Contract #: 04-0120F4Cty: SF/ALA Rte: 80 PM: 13.2/13.9File #: 69.25B**QUALITY ASSURANCE -- NON-CONFORMANCE REPORT****Location:** Changxing Island, Shanghai, P.R. China**Report No:** NCR-000533**Prime Contractor:** American Bridge/Fluor Enterprises, a JV**Date:** 11-Dec-2009**Submitting Contractor:** Zhenhua Port Machinery Company, Ltd (ZPMC), Changxing Island**NCR #:** ZPMC-0506**Type of problem:**

**Reference Description:** The fit-up of Floor Beam welds and cope holes deviated from the contract drawings in Segment 11EE

**Subject:** NCR No. ZPMC-0506

**Subject:** Reentrant Corner at Floorbeam Vertical Flange

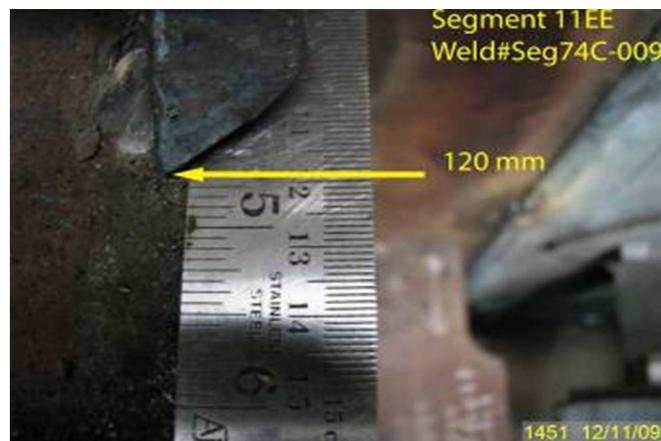
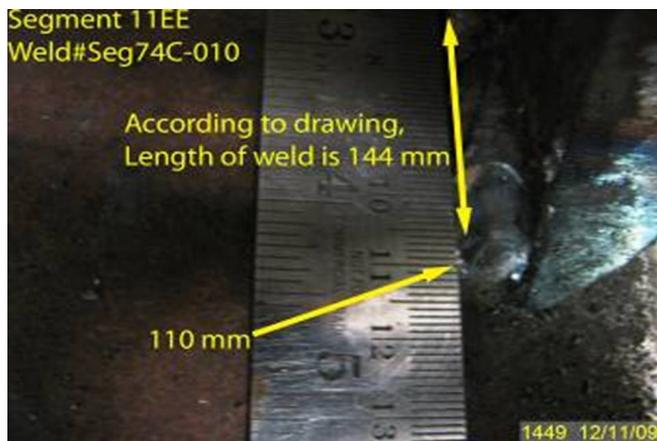
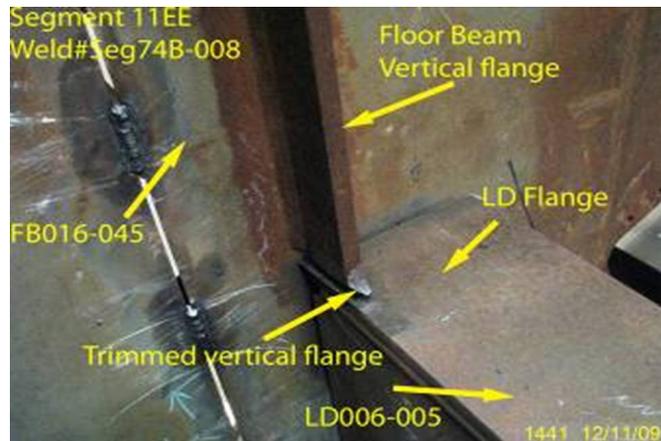
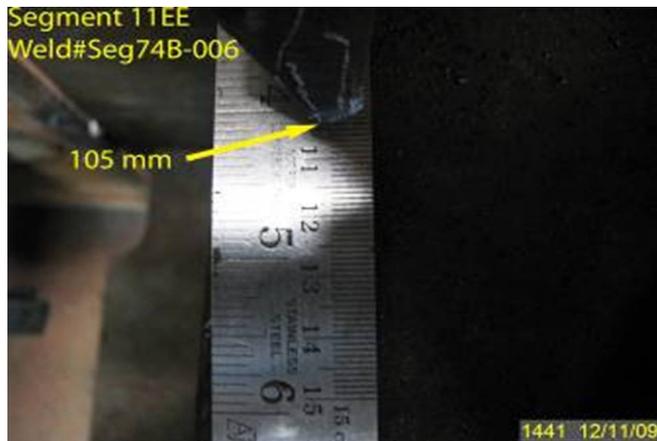
During a random visual inspection of segment 11EE located in Bay 14 of the Floor Beam (FB) vertical flanges to the Longitudinal Diaphragm (LD) flanges, the Quality Assurance (QA) Inspector discovered the following issues:

Due to fit-up issues, ZPMC has trimmed the FB vertical flanges, which reduced the designed radius and length of the partial joint penetration (PJP) welds. According to approved drawing the FB vertical flange should have a 50mm radius and the PJP welds should be 144 mm in length. This fabrication observed does not comply with approved drawing identified as X-7J.

1. Seg074B-006, @ Panel Point (PP)-107, Length of weld is 105 mm.
2. Seg074B-007, @ Panel Point (PP)-108, Length of weld is 115 mm.
3. Seg074B-008, @ Panel Point (PP)-108, Length of weld is 110 mm.
4. Seg074C-009, @ Panel Point (PP)-108, Length of weld is 120 mm.
5. Seg074C-010, @ Panel Point (PP)-108, Length of weld is 110 mm.
6. Seg074C-015, @ Panel Point (PP)-107, Length of weld is 115 mm.

Reentrant corner was found to be acceptable with a minimum radius of 25mm. Reference ABF-RFI-002075R0

Date: 2010-03-11  
File Name: SK-2075R0-1

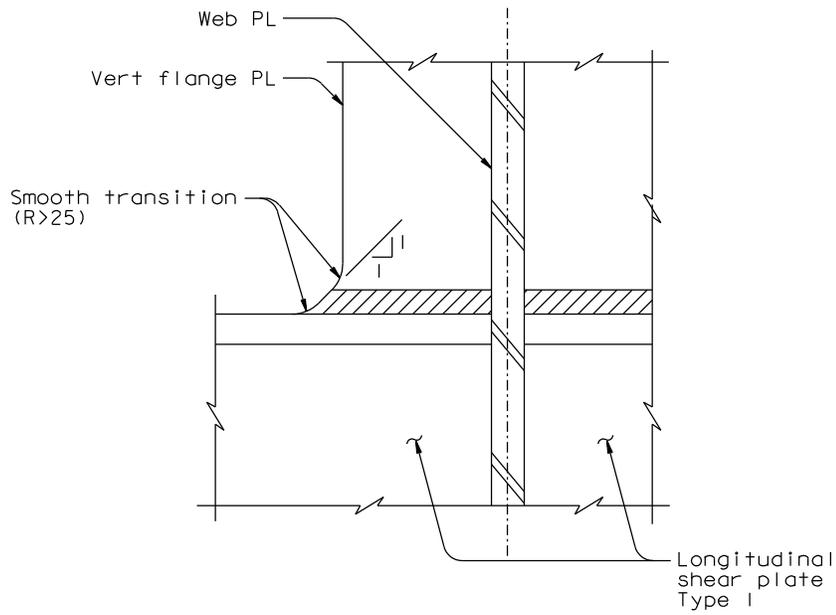
The reentrant corner (flare) in the approved drawings specify a 50mm radius for the connection between vertical floorbeam flange (stiffener) X7J and Longitudinal Diaphragm flange plate X42A. It has been noted that at some locations the as-built reentrant corner is less than 50mm in radius. Per AWS D1.5 Section 3.2.4, ABFJV considers the minimum acceptable radius for a reentrant corner as 25mm provided there is a smooth transition that meets the adjacent edges. Please confirm this understanding is correct.

Where the base metal of the vertical flange PL has not been altered (cut, grind, burn, etc) after initial welding was preformed and the welding passed the NDT testing, no action is needed.

Where the base metal of the flange PL has been altered by any mechanical means (cut, grind, burn, etc.), the reentrant corner shall be transitioned at a 1:1 slope for the height of the PJP 11(8). A smooth transition of radius 25 mm or greater shall be provided at the start and finish of the 1:1 transition.
